Pacwest Center

Building *repositioning*

DESIGN ADVICE REVIEW
02.18.2016

CANOPIES

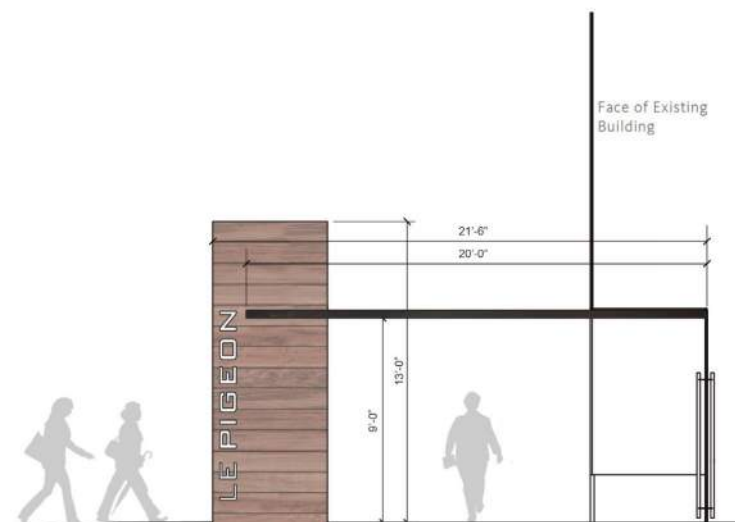
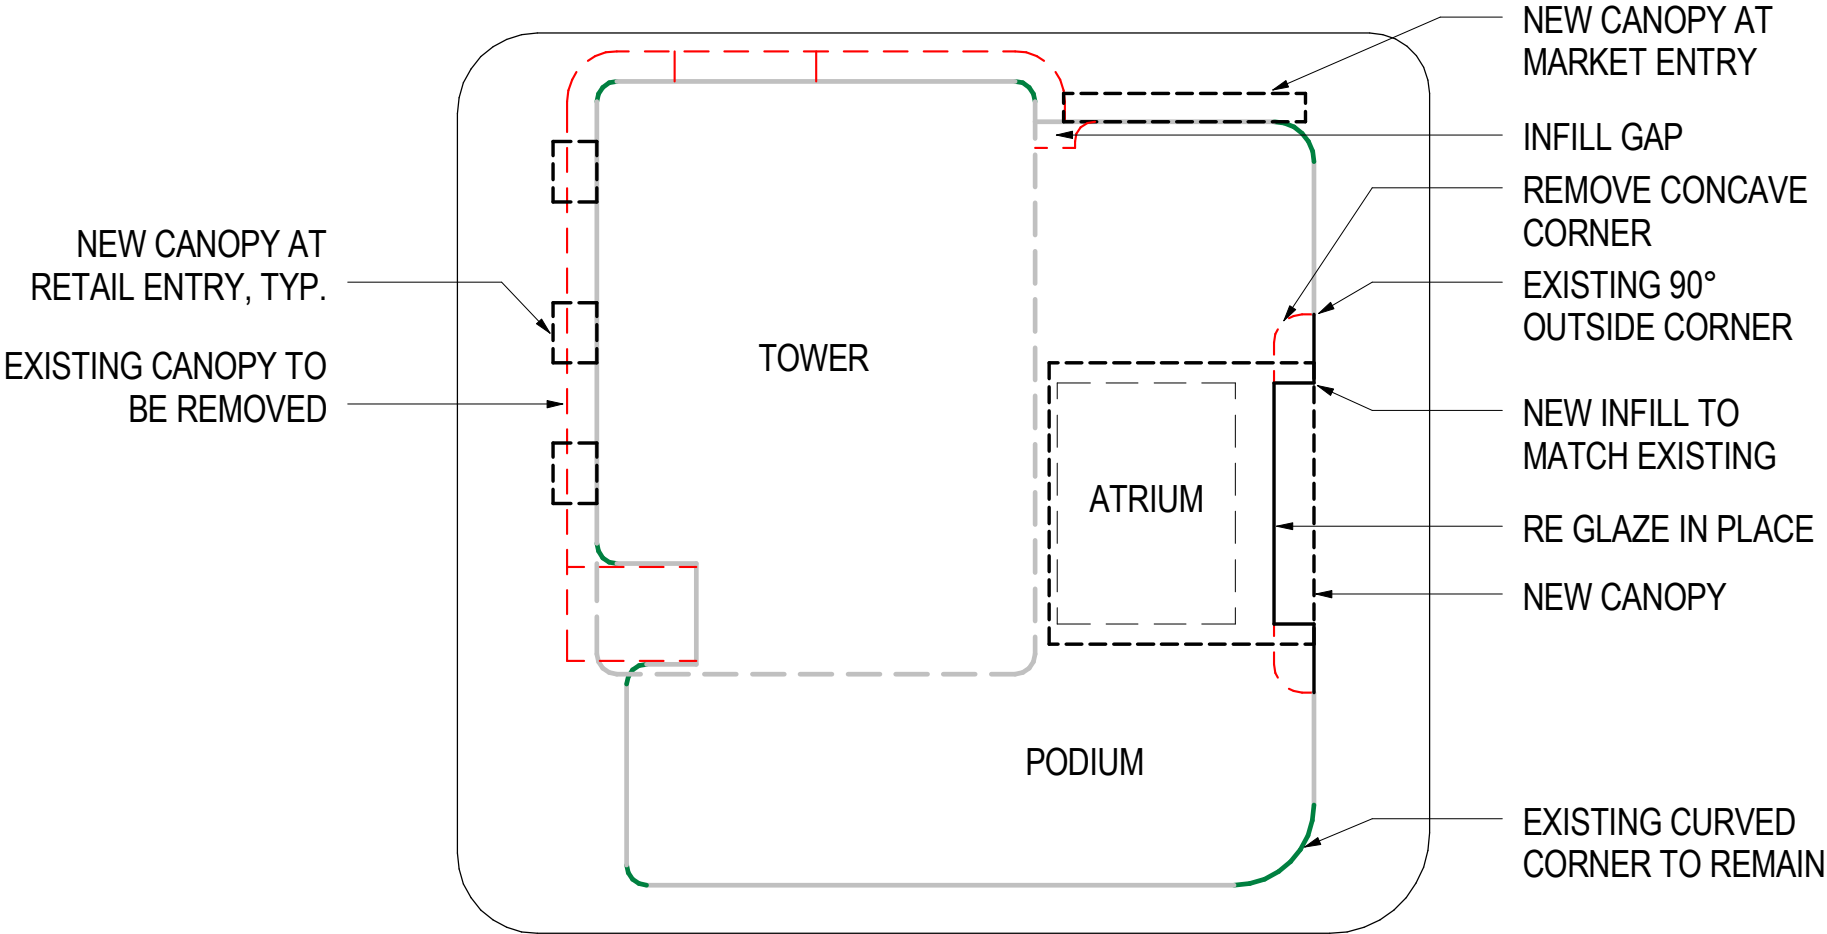
Canopies. Please provide details for the proposed canopy in the DAR packet. As noted above, this building is noted for its curves and the proposed canopy is a distinct departure from that. Staff supports the idea of a canopy to mark the entrance but also notes that the overall design must be coherent with the existing building.

Staff also notes that while new canopies are proposed, it appears that the proposal will result in a net loss of canopy coverage along the perimeter of the building. Please be prepared to speak to this at the Design Advice.

- New canopies use simple geometry and materials that blend with existing (black steel)
- Wood is used to add warmth
- Locations of canopies are purposeful, and intended to increase tenant visibility and provide protection where pedestrian/patron concentration is highest.

WOOD

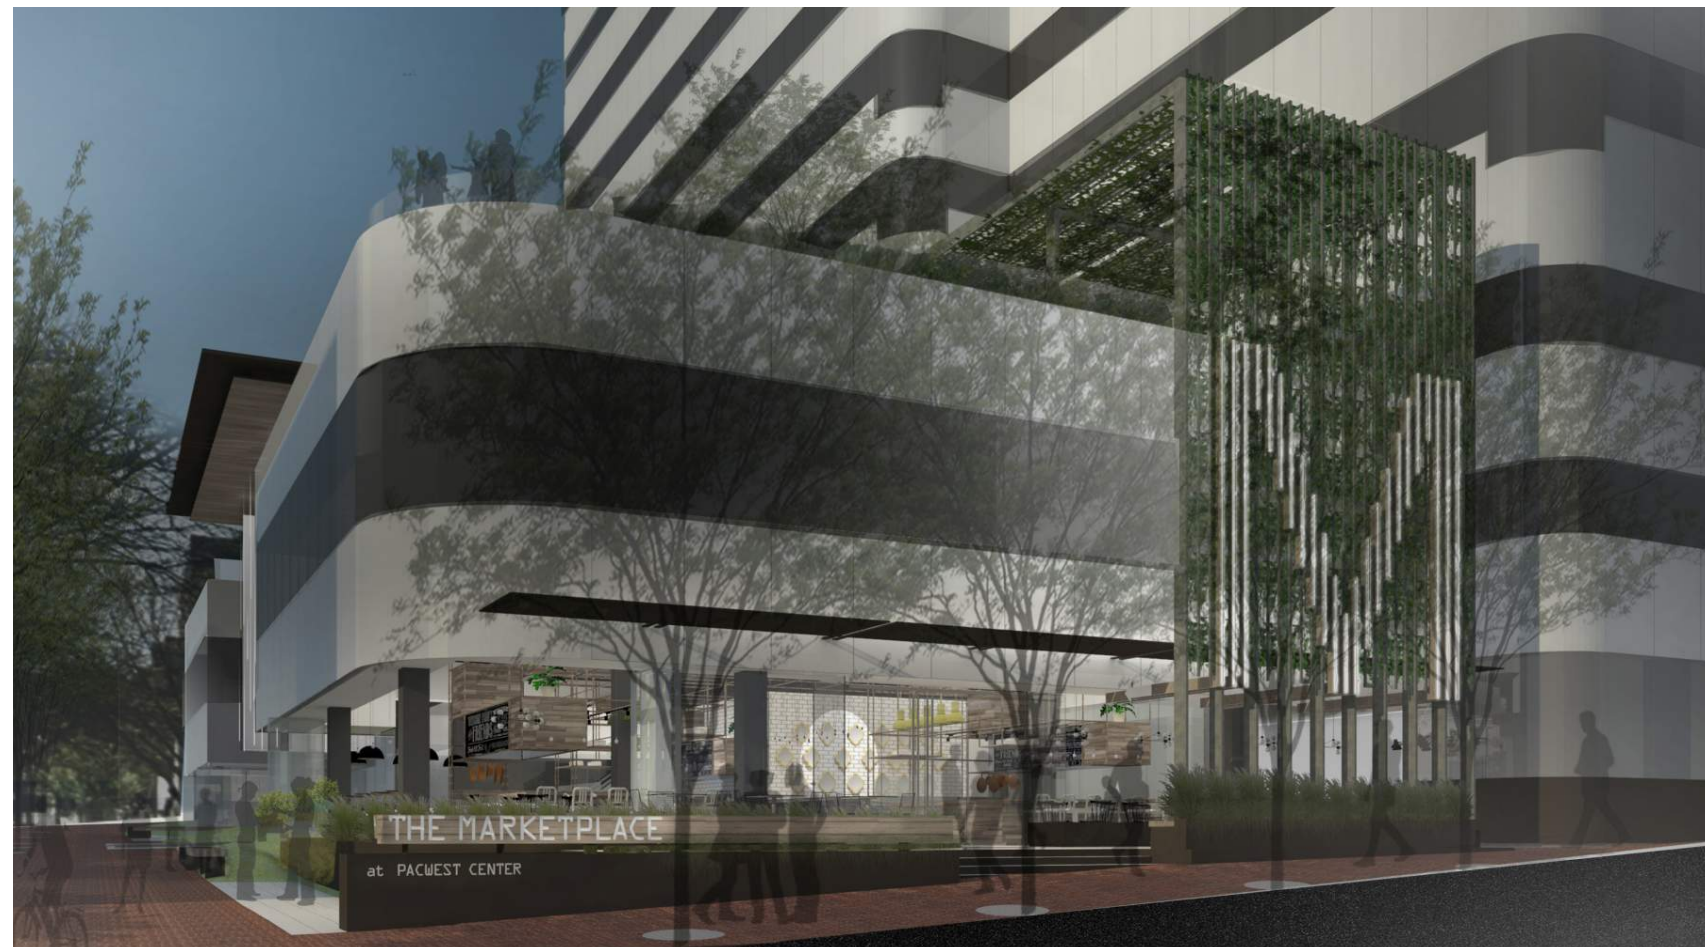
Wood. The Design Commission has had reservations about wood at the ground floor, Particularly when the wood is not weather-protected by overhangs and is located in high traffic Areas due to concerns about accidental and intentional marring. Staff notes that the Existing building is located between the bus mall couplet and therefore has very high levels of pedestrian traffic. In addition, while the applicant seeks to add warmth to the building, the Addition of wood introduces a foreign element into the existing material palette, which may Cause additional concerns for the Design Commission. Staff suggests the applicant Investigate alternative ways or materials to add warmth that is more in keeping with the Existing building language.

- Wood is intended to provide visual warmth to the building – a key comment from testimonials
- Wood exists on the interior of the building in all the elevator lobbies.
- Products being explored are either impregnated natural materials or synthetic woods in order to provide durability

SIGNAGE

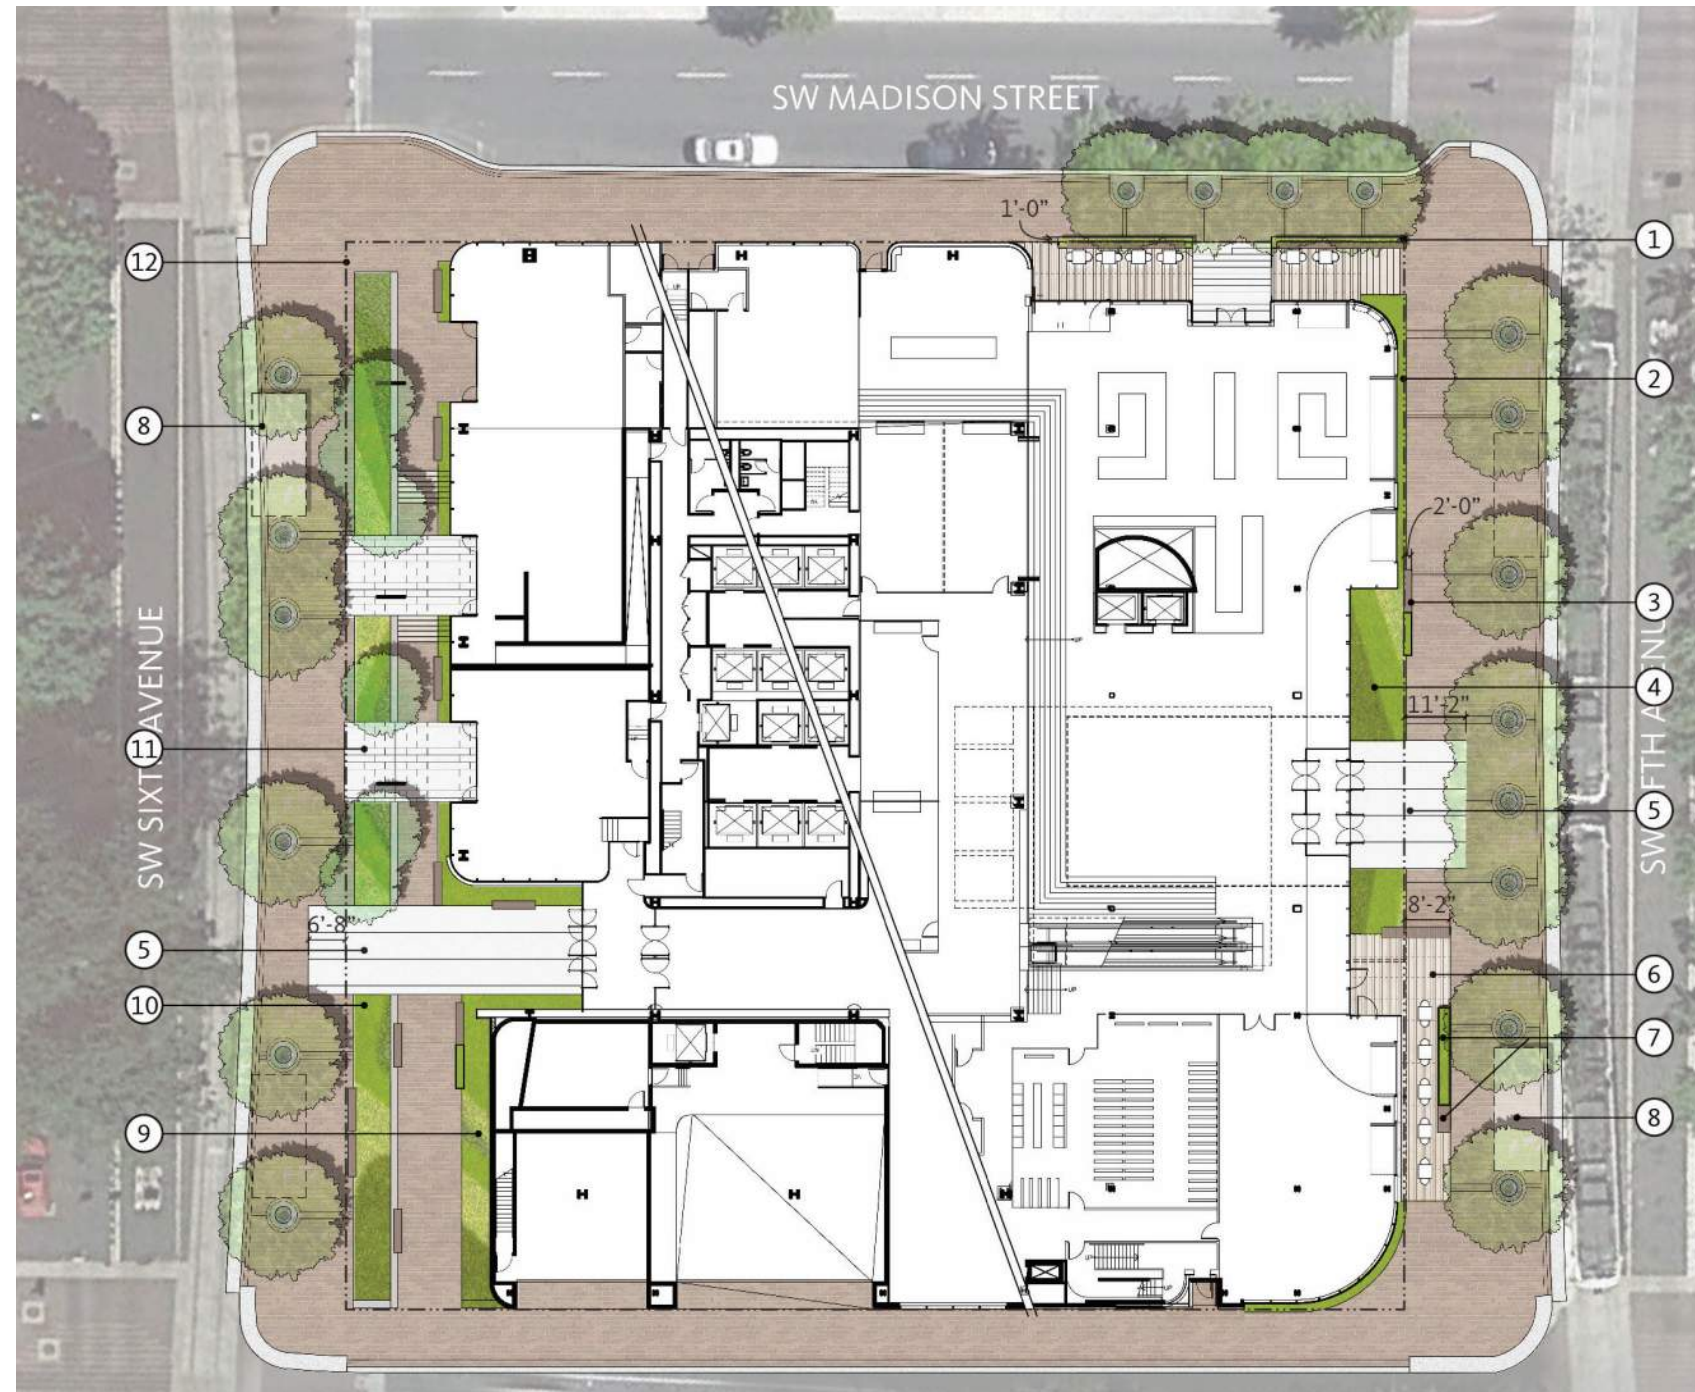
Greenery. As staff noted in the Pre-Application Conference, the Design Commission has Previously expressed hesitation with vertical landscaping elements, as is proposed at the north marketplace entrance. The Design commission has concerns about long-term maintenance of this type of landscaping treatment and is typically not satisfied with assurances of proper management. A maintenance agreement may be required in order to gain approval for this feature. Staff suggests consideration of alternative treatments.

Signage. Area totals for all existing and proposed signs must be provided at the time of land use review. Signs larger than 100 square feet in area will require a Modification; staff discourages such Modification requests as signage should be pedestrian scaled per the Design Guidelines. Details must be provided for all signs larger than 32 square feet; these details must include sign structure, materials, method of attachment, and method of illumination, if applicable.

- Building management is committed to the required maintenance of the vines.
- Vine species being explored, *Clematis armandii* or *Passiflora edulis* will perform well in this climate.
- Intention is to add enough planted material to keep the vine walls full.

- Proposed sign areas will be calculated during upcoming Design Review
- Intention is to ultimately submit signage under separate permit

PRIVATIZATION OF THE RIGHT-OF-WAY

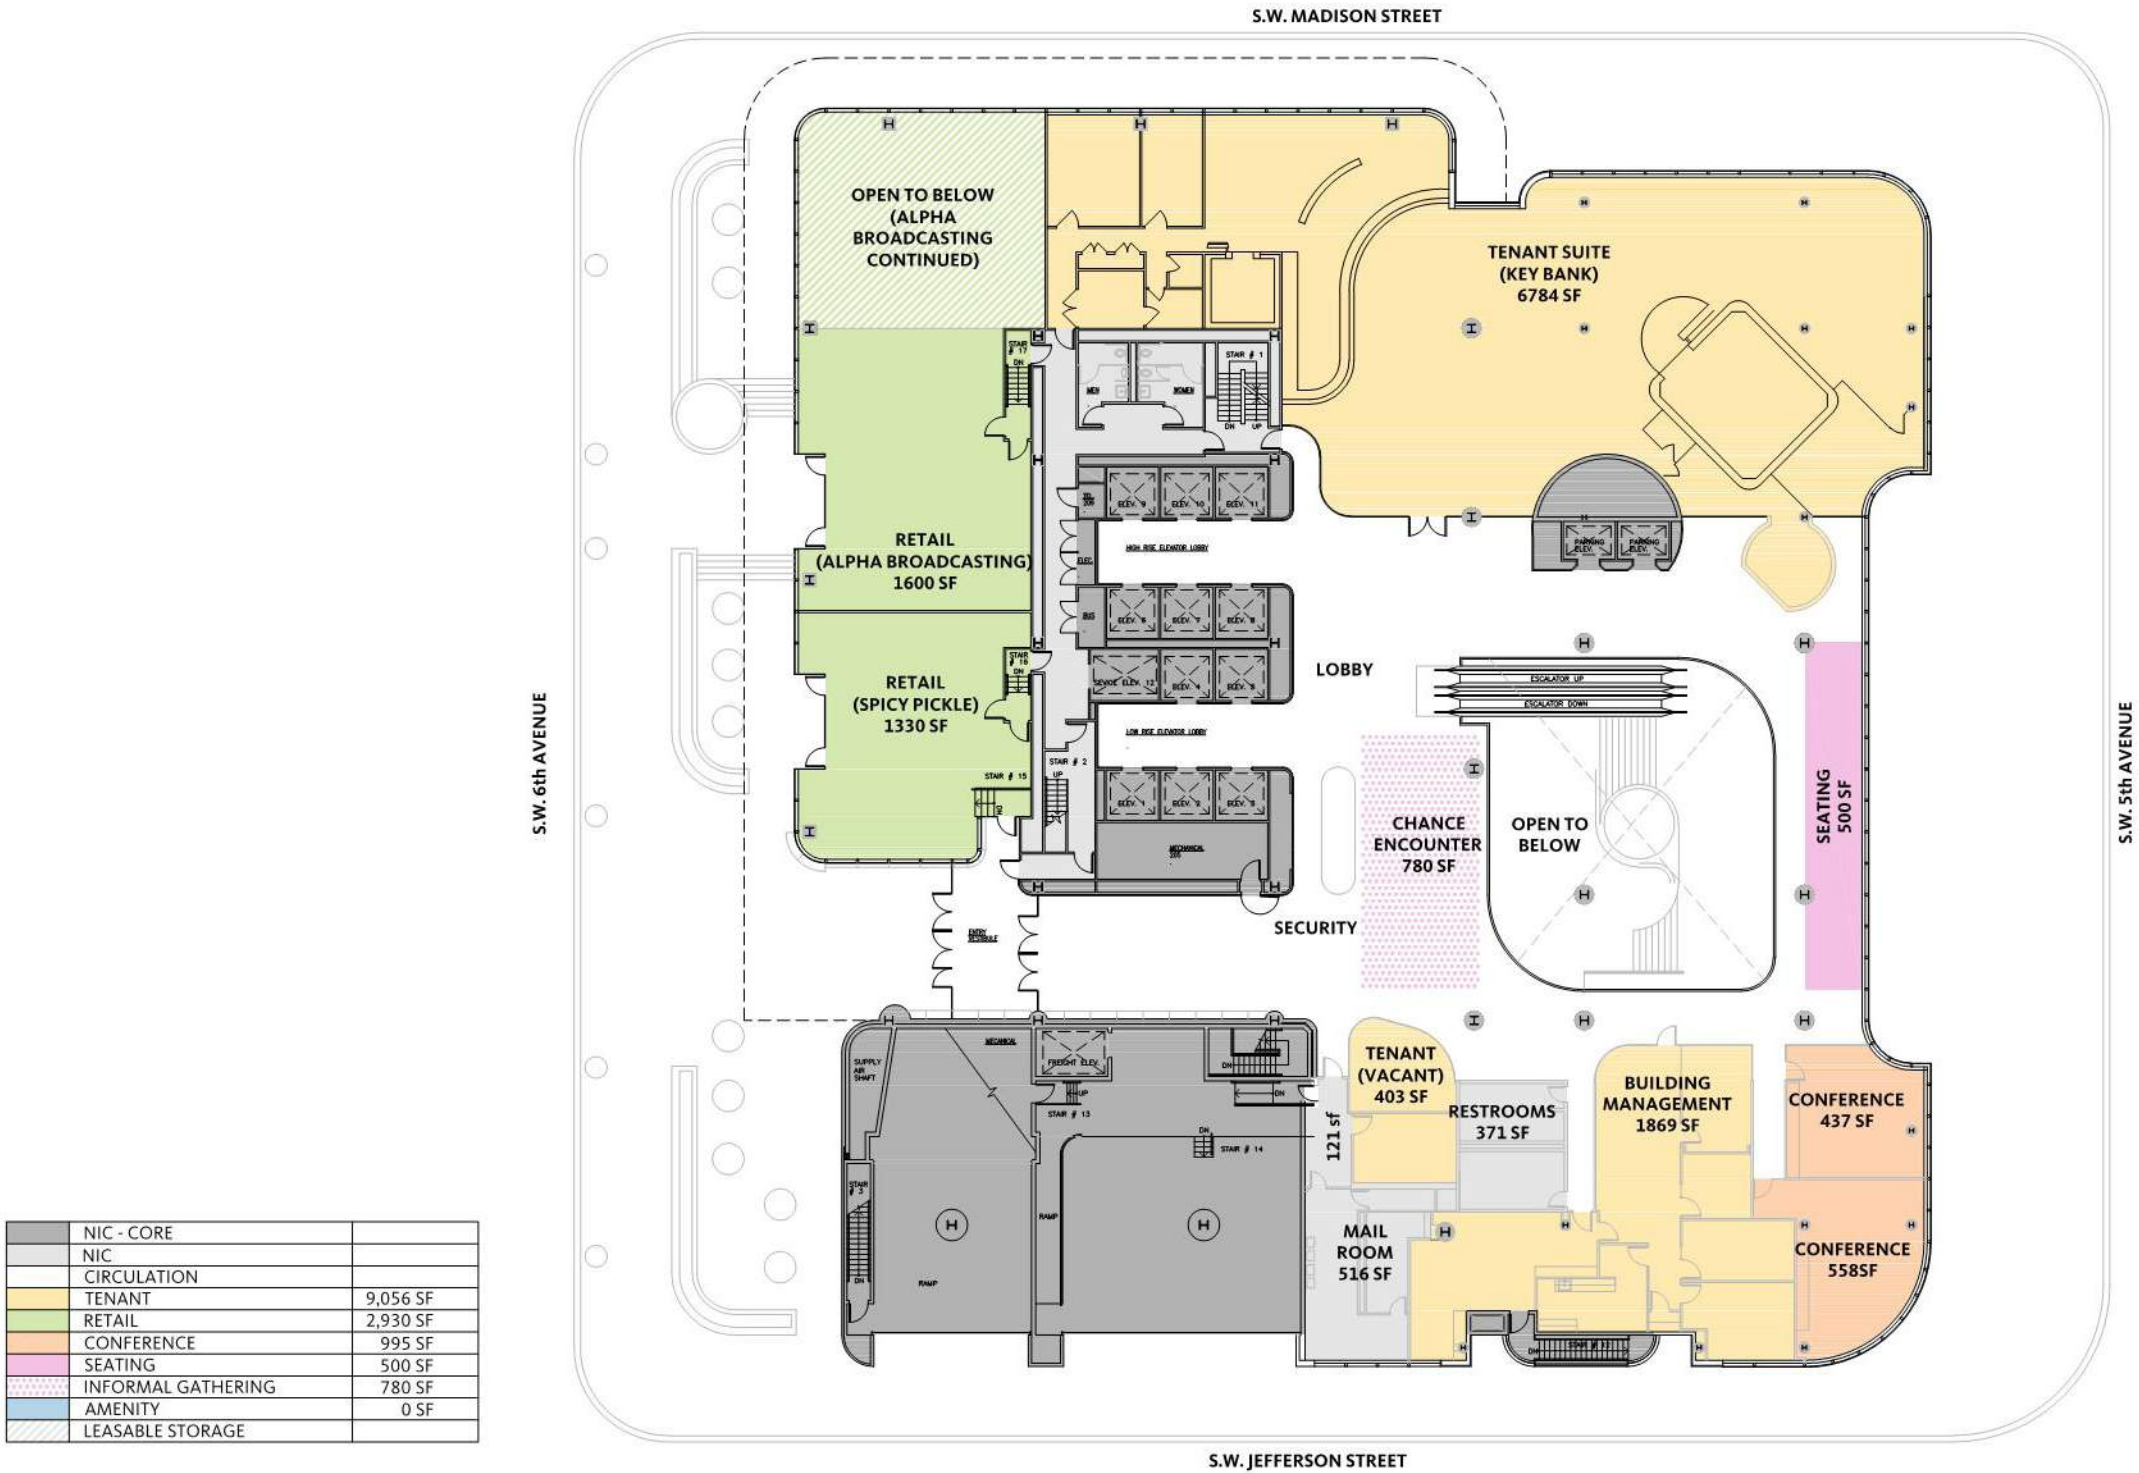
Privatization of the Right-of-Way. Staff has concerns about the proposed paving materials, permanent seating, and planters in the right-of-way, as this results in privatization of the public realm. Staff suggests that all changes in paving materials and planters be located within the property lines. Any seating within the right-of-way should be non-permanent. However, as was suggested during the Pre-Application Conference, since planters, which currently provide opportunities for seating are proposed to be removed, new seating opportunities should be provided on portions of the site not occupied by the building. All non-standard improvements in the right-of-way will require z approval prior to final Design Review approval
